TO: Knoxville-Knox County Planning Commission
FROM: Samiul Haque, Planner
DATE: August 6, 2026
SUBJECT: Appeal of an administrative determination for a Middle Housing application
FILE #: 8-I-26-0B; Agenda Item #50

The applicant is appealing Planning staff's comments on a pending Middle Housing application for a proposed 3-unit structure at 1409 W Fifth Avenue (KnoxPlans project # IRC-NEW-25-0549).

1 ARCHITECTURAL SITE PLAN
3/16" = 1'-0"

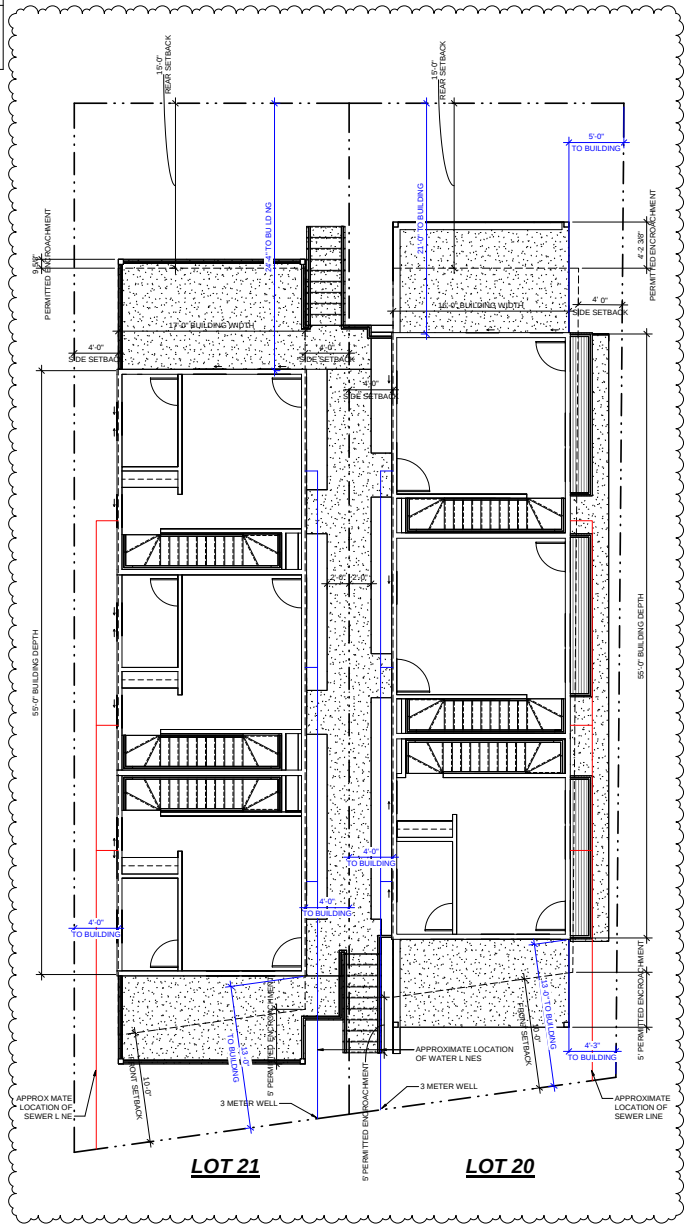
<i>Responded by: MARLOW BUILDERS - 8/19/25 3:19 PM</i> MH Approved by Planning Commission 8-3 on 14 August 2024. Agenda item 31; file 8C25OB.			
	Ref.# 30	Planning Review	Lindsay Lanois	7/29/25 1:27 PM	Cycle 1
	Resolved	Article 4.6.C: Provide an actual front setback measurement, measuring from the front property line to the front building line.

Comment				
		<i>Responded by: MARLOW BUILDERS - 8/19/25 3:19 PM</i> See revised A101.			
	Ref.# 31	Planning Review	Lindsay Lanois	7/29/25 1:27 PM	Cycle 1
	Resolved	Article 4.6.E.4.b: recesses or projections in the building wall of any front or side elevation that exceeds a length of 50, which shall be at least 2 wide. Side elevations do not meet this requirement.
